Resilience Research Center

City of Madison
Land Use Application Submittal
Resilience Research Center

8 September 2010 / Revised 22 October 2010

Sheet No. 11.0

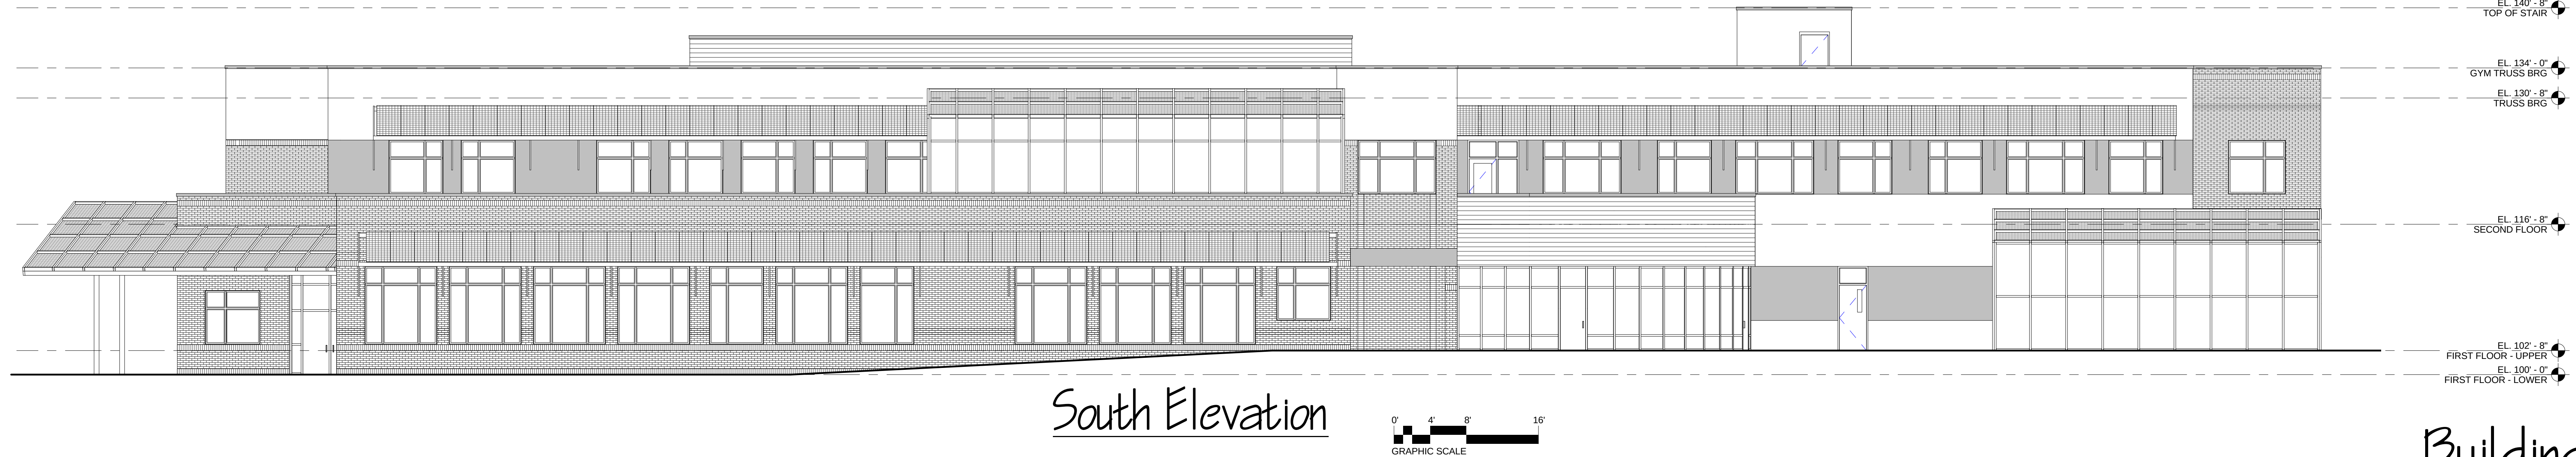
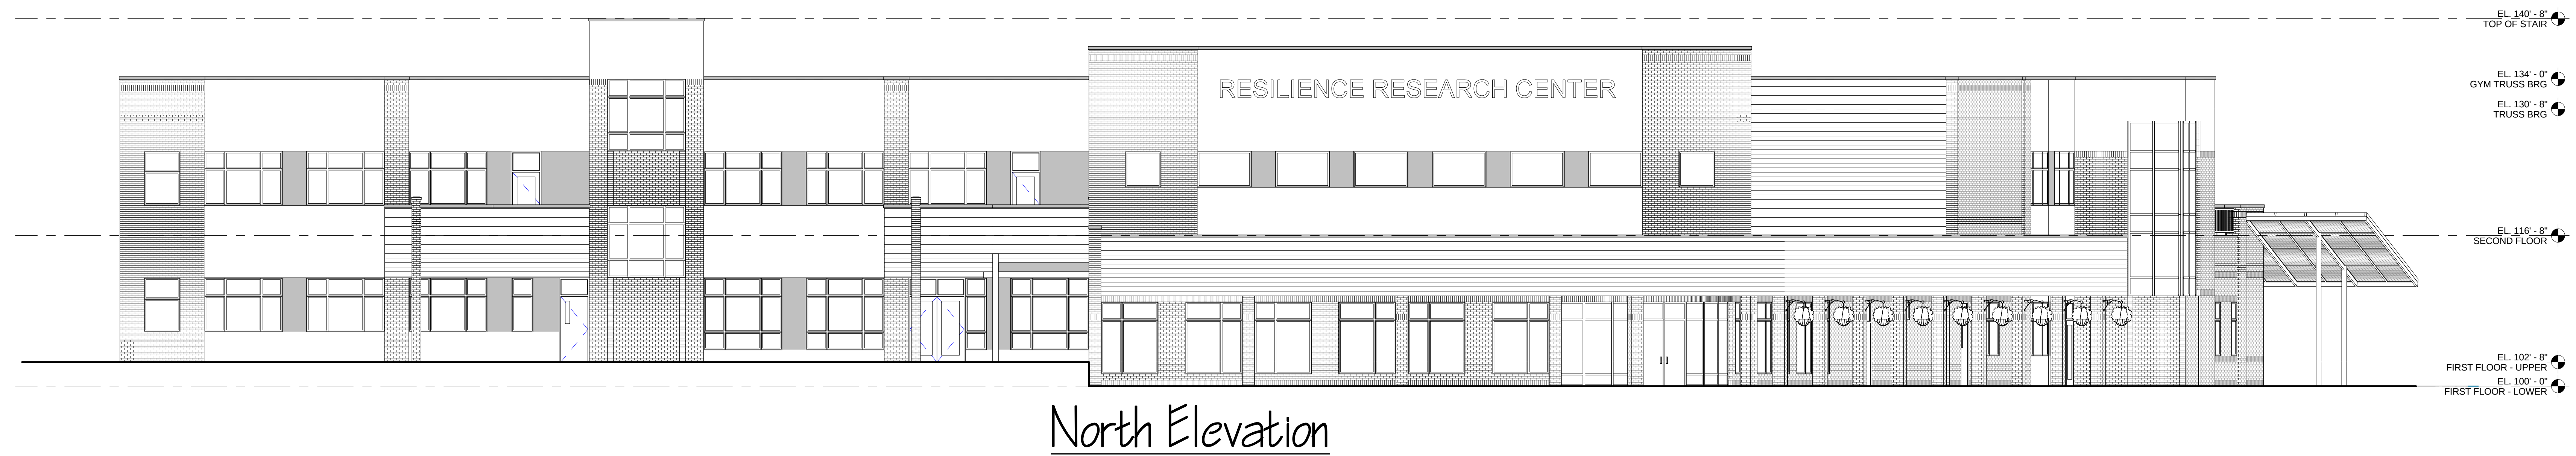
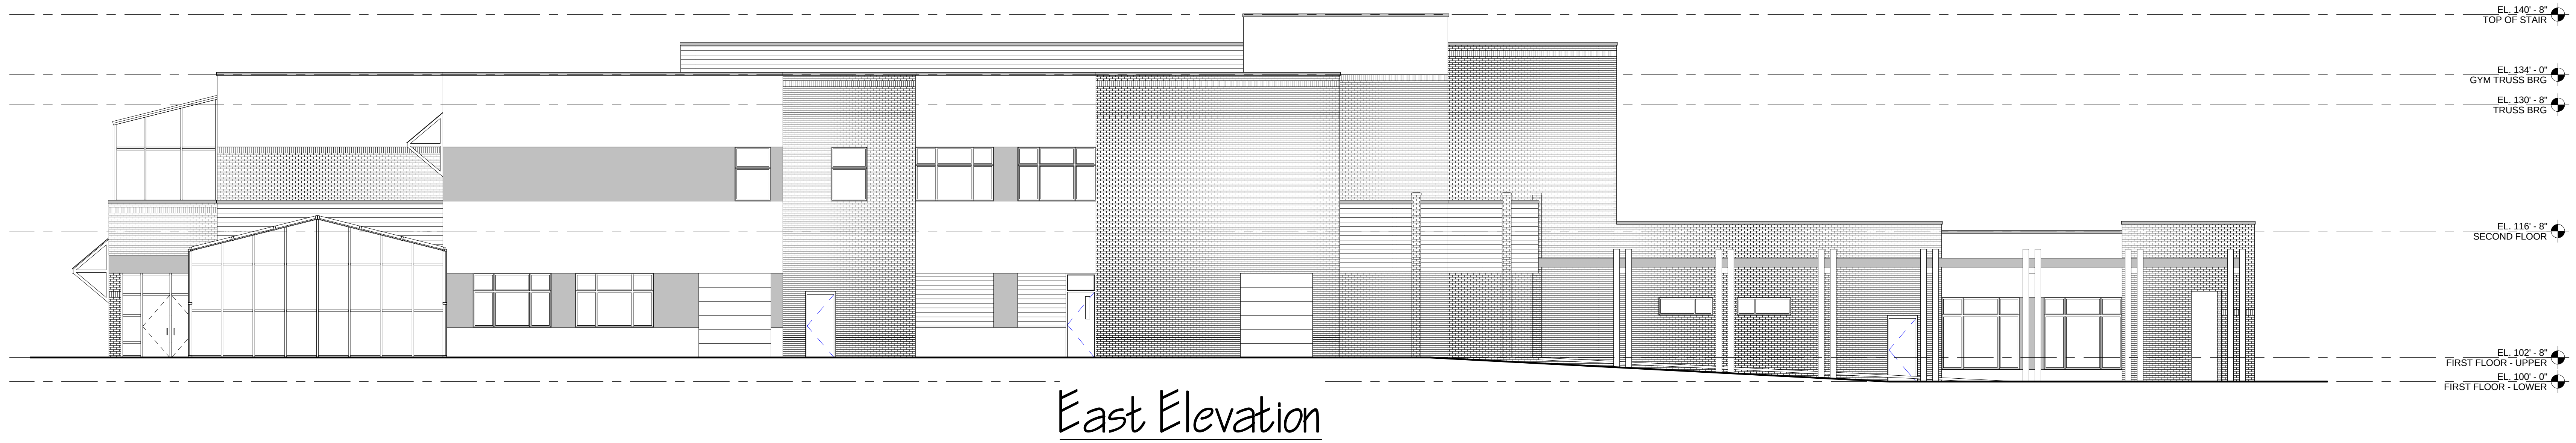
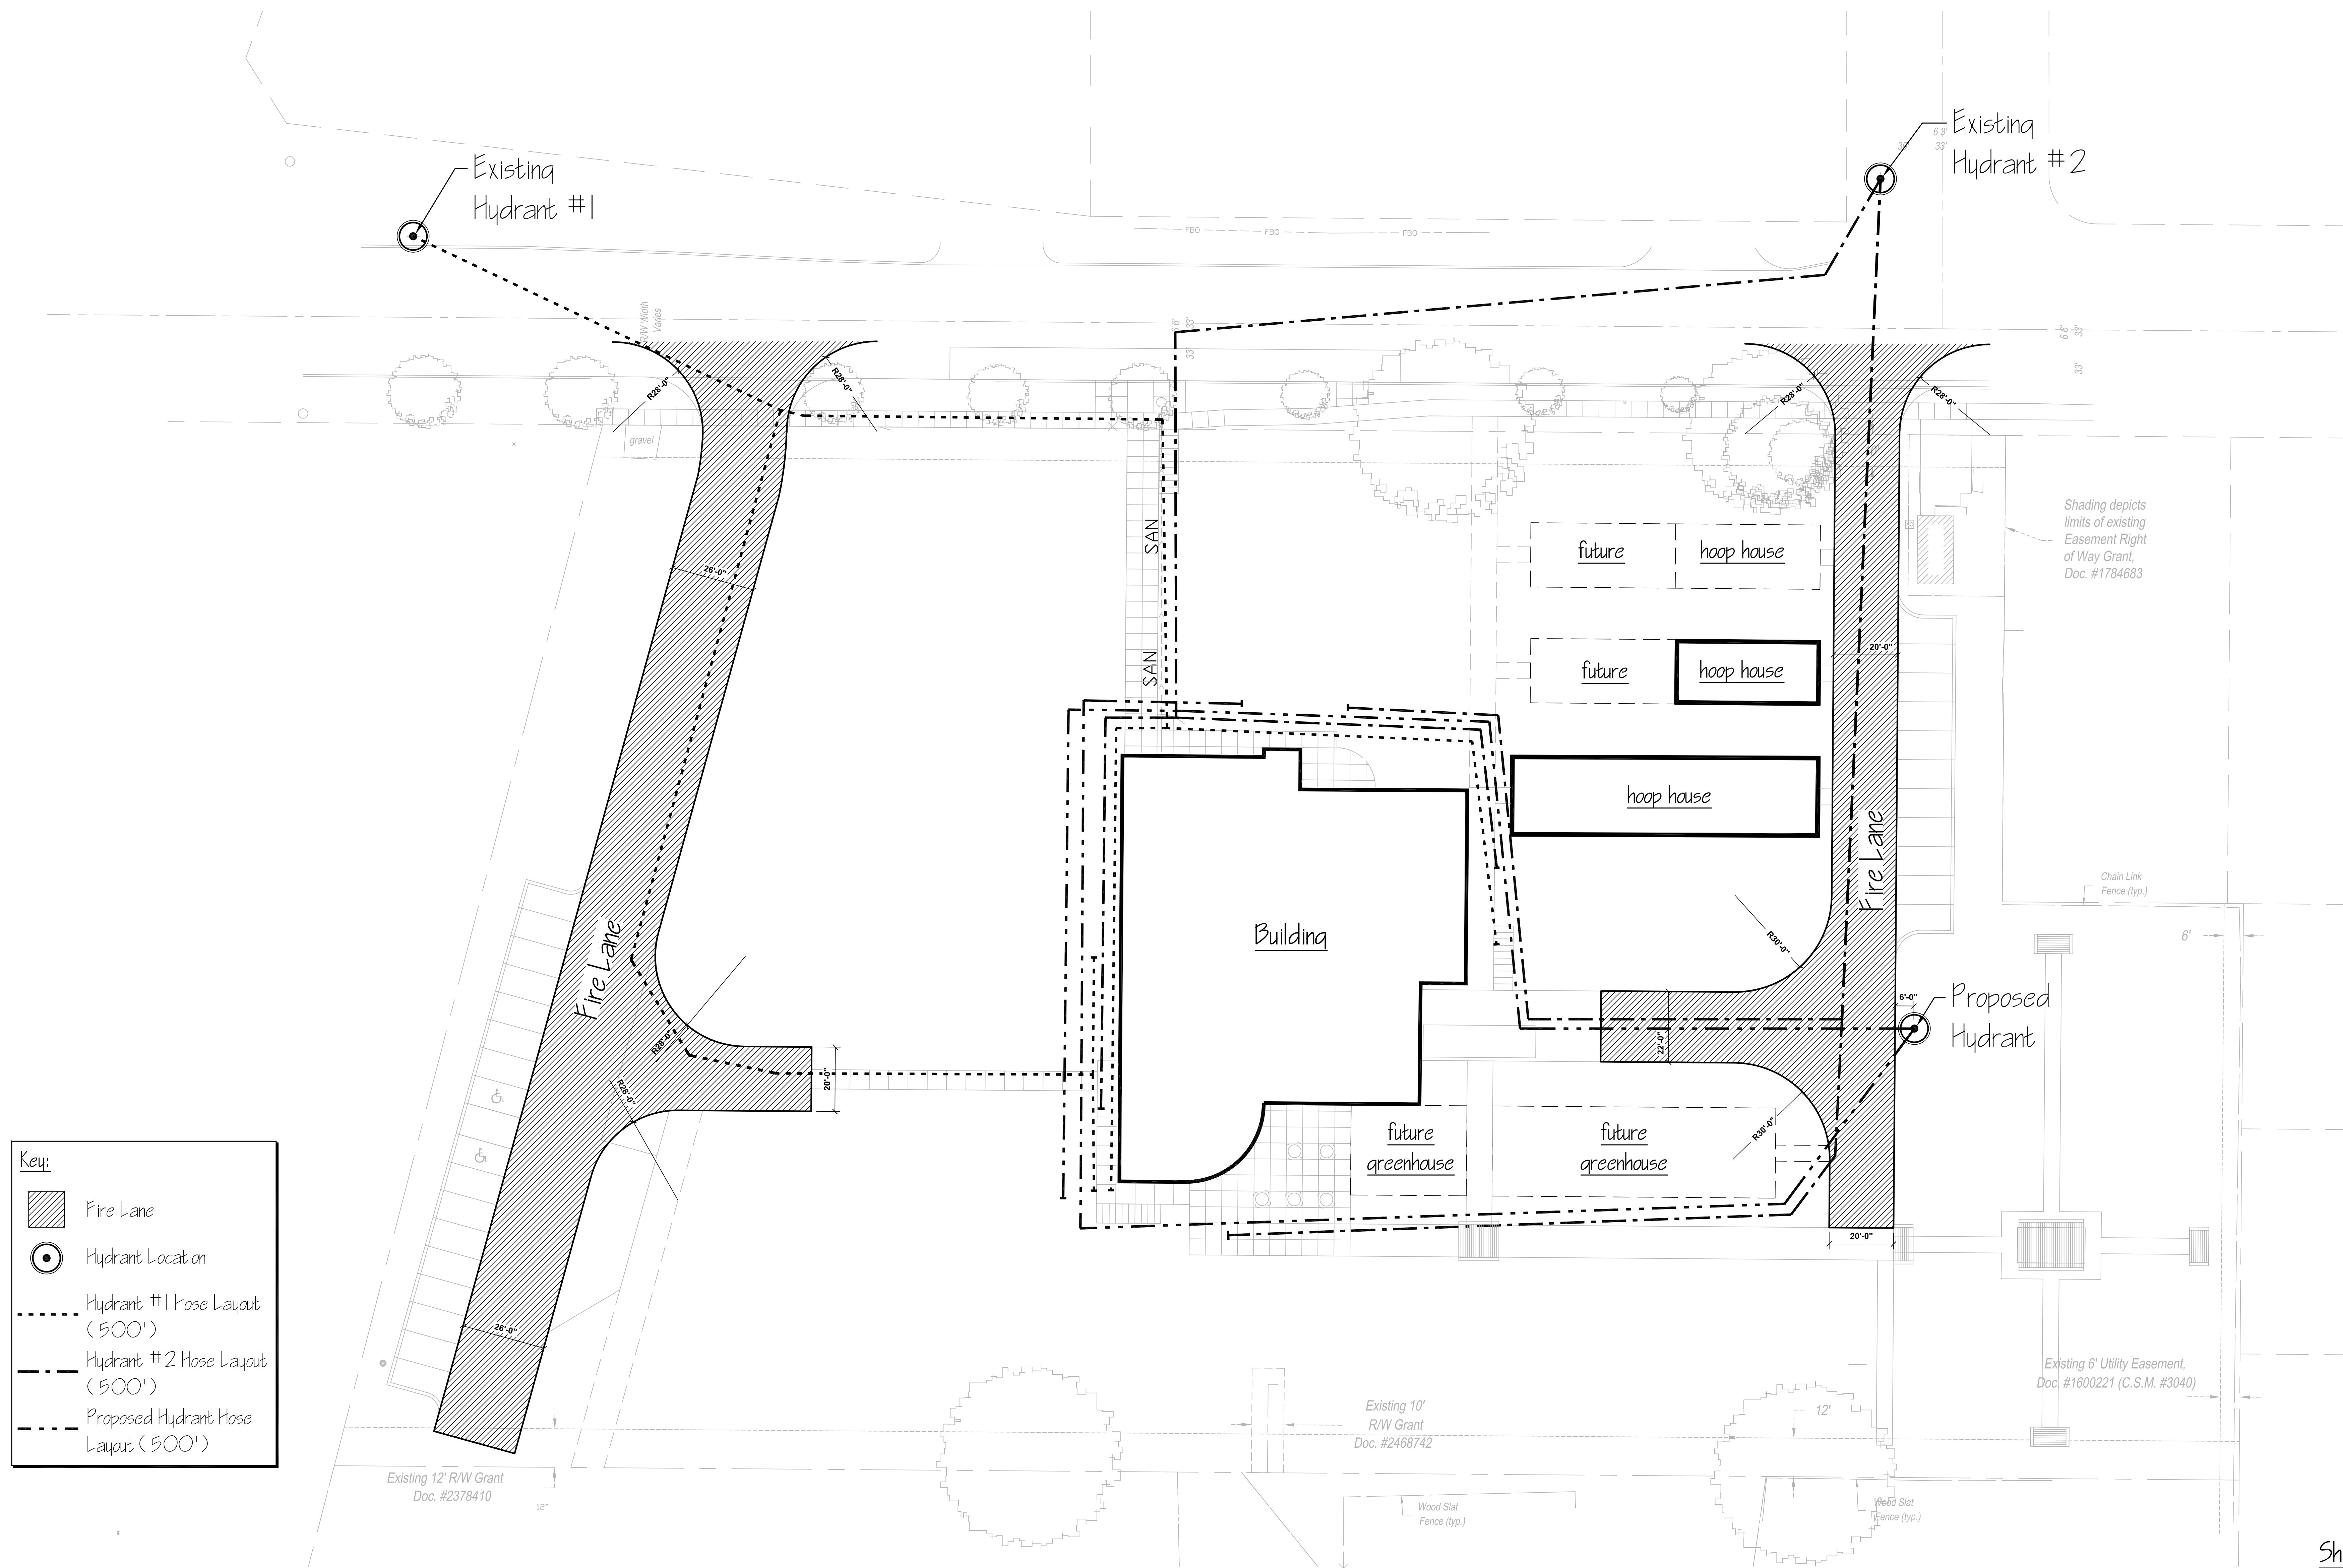
REVISED 10-22-10:

- ALTERED STAIR ORIENTATION / LOCATIONS
- MODIFIED MAIN ENTRANCE
- UPDATED MATERIALITY AND WINDOW LAYOUT
